Product Change Notification / SYST-28KSUP099

ERRATA - USB72x6/USB7252 Silicon Errata and Data Sheet Clarification Document Revision

USB72x6/USB7252 Silicon Errata and Data Sheet Clarification

FIGURE 1: TOP MARKING SILICON REVISION INDICATION

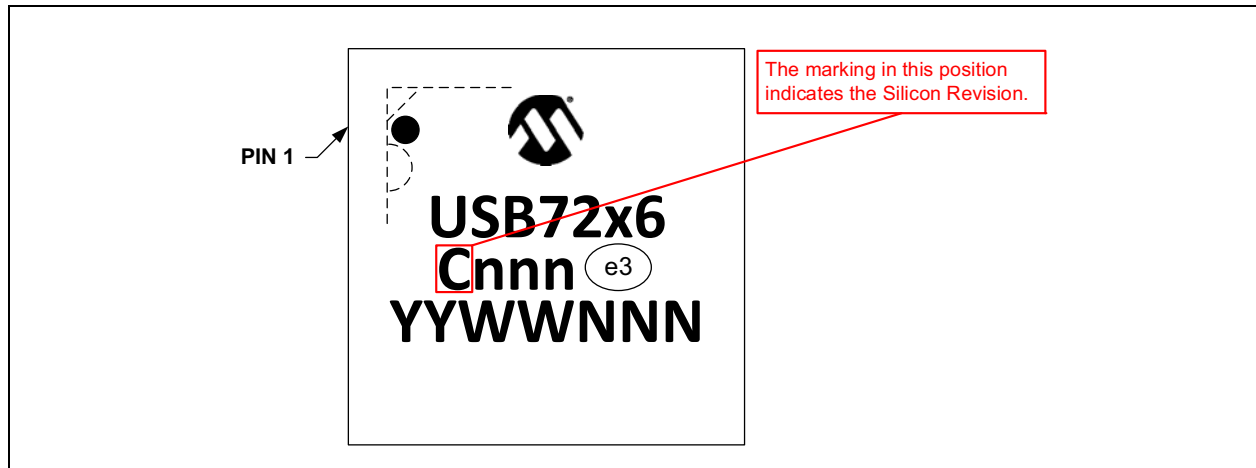
- Description of Change:**
- 1) All section: Updated document for C1 silicon.
 - 2) Table 1: Added C1 silicon revision to list.
 - 3) Figure 1: Updated figure to indicate where the silicon revision can be determined in the package top marking.
 - 4) Table 2: Added affected silicon revisions column.
 - 5) Modules 1., 2., 4., 5., 6: Updated Plan section to indicate the erratum is fixed in revision C1 silicon.
 - 6) Module 7: Added new module.
 - 7) Module 8: Added new module.

Note: [Figure 1](#) details the top markings of an example part and highlights the location of the silicon revision. Other top marking values may differ (lot codes, location of manufacture, and so on).

FIGURE 2: TYPE-C DISCHARGE WORKAROUND FOR MODULE 3

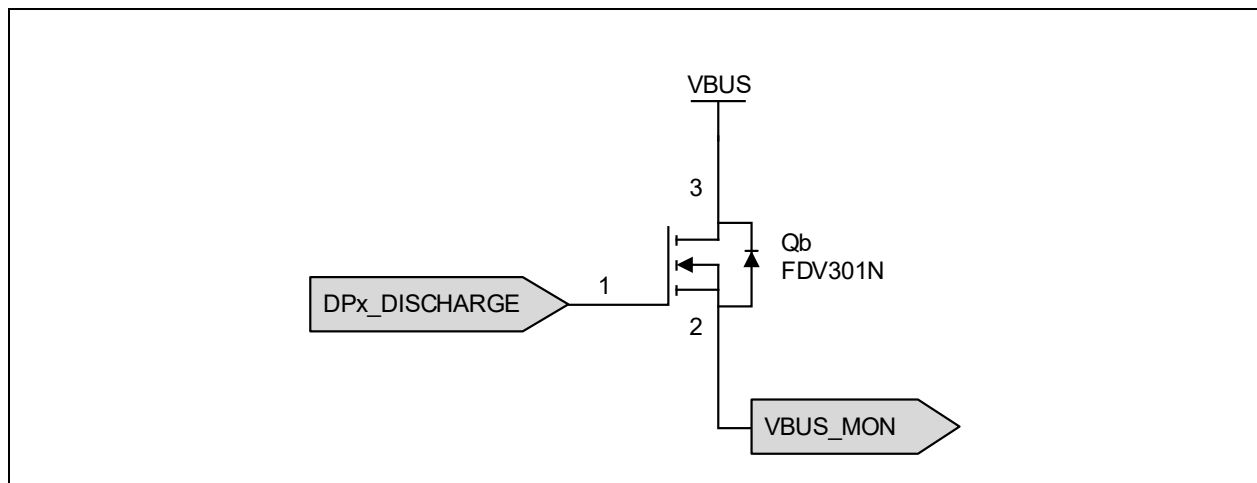
One requirement for USB-IF compliance certification of a system with an exposed Type-C port is the *Port Power On/Off* test. This test is part of the HUBCV suite of *Command Verification* tests for USB 2 devices. As part of this test, the hub must discharge VBUS, and then energize VBUS in response to CLEAR_FEATURE and SET_FEATURE commands from the test host.

Frequently, these ports will be implemented with electrolytic VBUS load capacitors, which retain a small residual charge that is released slowly compared to the timing of the discharge. In such cases, as energy is released from the capacitor the voltage can drift upward slightly after the discharge, which can cross the VBUS_DET threshold for detecting VBUS high. In the sequence of the Port Power On/Off test, this can inhibit subsequent turning on of VBUS in response to commands from the test host and the test fails.

Type C ports that have a large electrolytic capacitor may require this workaround to pass the HUBCV Port Power On/Off test.

In reference designs for USB7216 and USB7252 devices, an N-channel MOSFET with a V_{GS} less than 1.0V is connected between VBUS and VBUS_MON, with gate control from the DISCHARGE signal. This additional component creates an additional current path as the discharge is monitored by VBUS_MON, which biases VBUS_MON higher. This results in discharge to a lower voltage than what is otherwise achieved, and compensates for any residual energy that the capacitor releases after the discharge. At times other than the discharge, the MOSFET is turned off and does not influence VBUS.

No components of the reference design need to be removed; only the MOSFET is added.
